# SERVICE INSTRUCTIONS

Bulletin NO. 0088

## NOTICE

## MW Part Number 73400 Strut Mount Carbon Rotor Floating Brake Disc

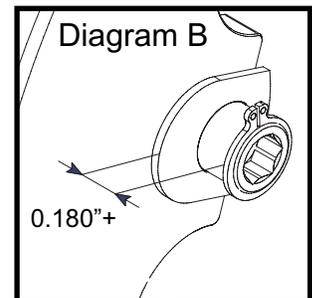
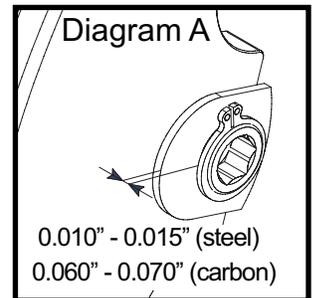
Start by raising the front end and spinning the front wheel. Next lightly apply the brakes and let the rotor find its position. The rotor should be straight and it should be resting against the outer brake pad in the caliper. Measure from the inside of the retaining ring to the D-Drive surface.

**NEW PADS** - The stainless D-Drive bushings in the rotor should be approx. 0.010" - 0.020" (0.060"-0.070" on the 73400 carbon/carbon kit) from the snap ring on the D-Drive bushing. See Diagram A. If the distance is greater than 0.180" **the caliper brackets must be modified or replaced.**

**WORN PADS** - Measure the wear on the outer pad. New steel-rotor pads are 0.425" thick including the backing plate, and Carbon pads are 0.375" including the backing plate. Subtract the measured thickness from the corresponding (carbon or standard) new pad thickness. If the measured distance minus the wear is greater than 0.180" **the caliper brackets must be modified or replaced.**

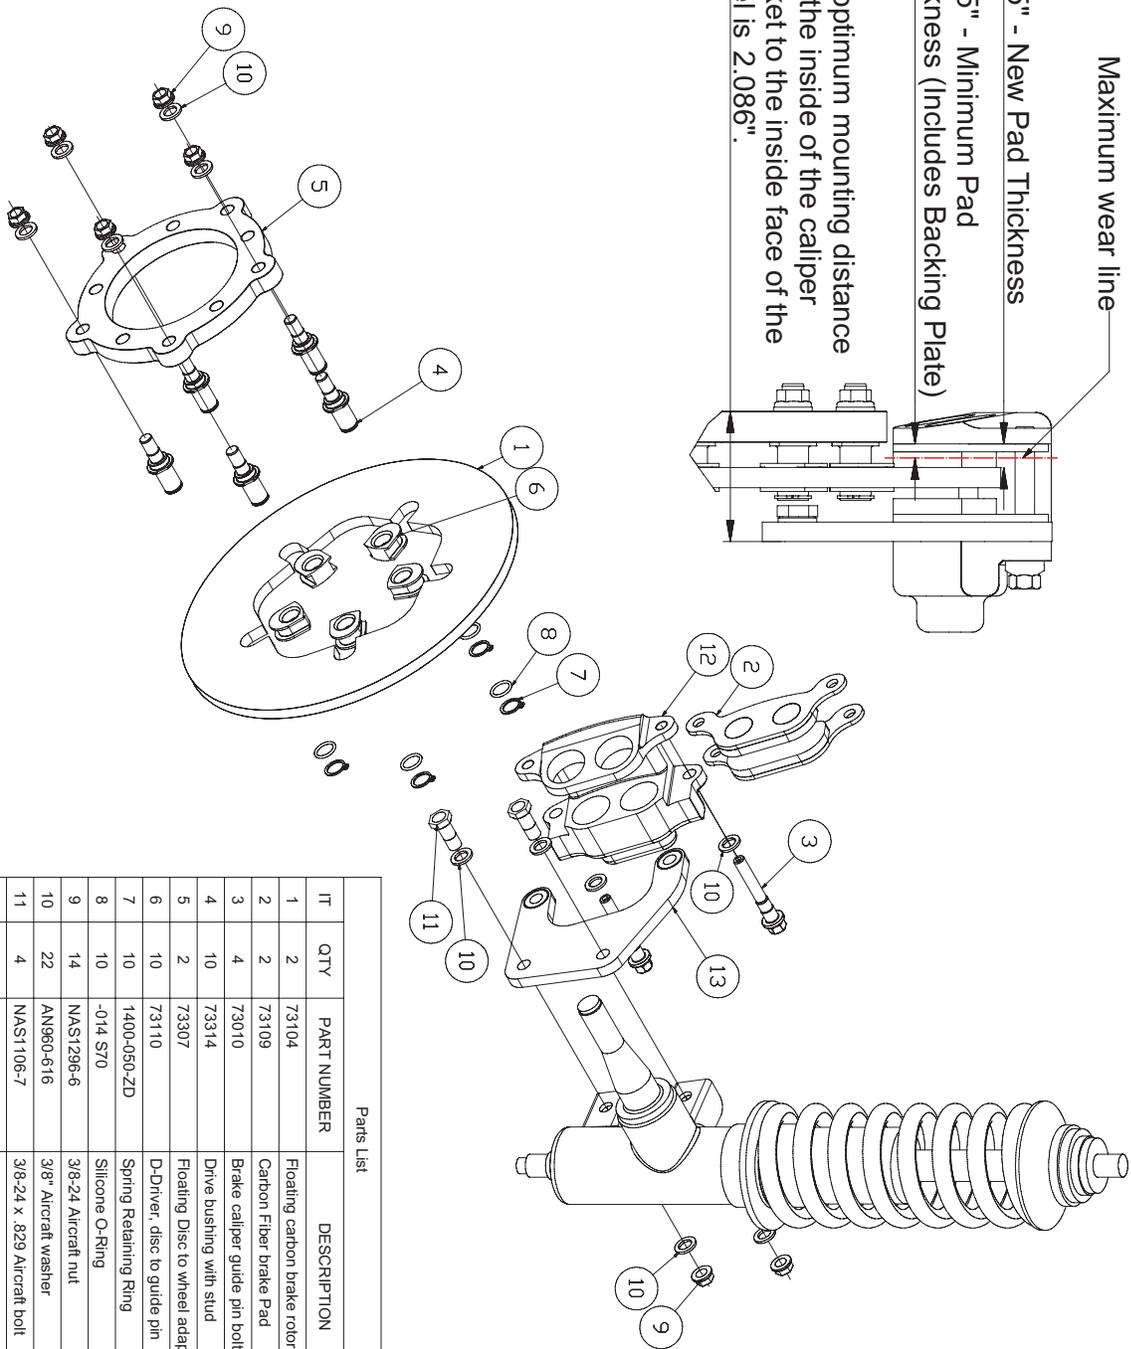
The optimum mounting distance from the inside of the caliper bracket to the inside face of the wheel is 2.086".

- 1) Remove the two mounting bolts from the caliper and remove the caliper and brake pads.
- 2) Remove the caliper mounting bracket (#13) from the strut.

- 3) Send both caliper brackets to Mark Williams Ent. to be modified. You can also set the bracket up on a milling machine and remove 0.180" from the two raised areas on the inner face of the bracket. Send the Brackets to:

**Mark Williams Enterprises**  
765 S. Pierce Ave  
Louisville, CO  
80027
- 4) Re-install caliper bracket on strut (2 additional washers (#AN960-616) will be required on each bolt, or use shorter bolt (NAS1106-7 available from MW) to make up for the material removed for the bracket)

- 5) Re-install the caliper and brake pads and torque the mounting bolts to 25 ft/lbs.
- 6) New caliper brackets are also be available from Mark Williams Ent. New brackets have the raised areas and spot faces removed. These brackets do not require the different hardware mentioned in step 4.
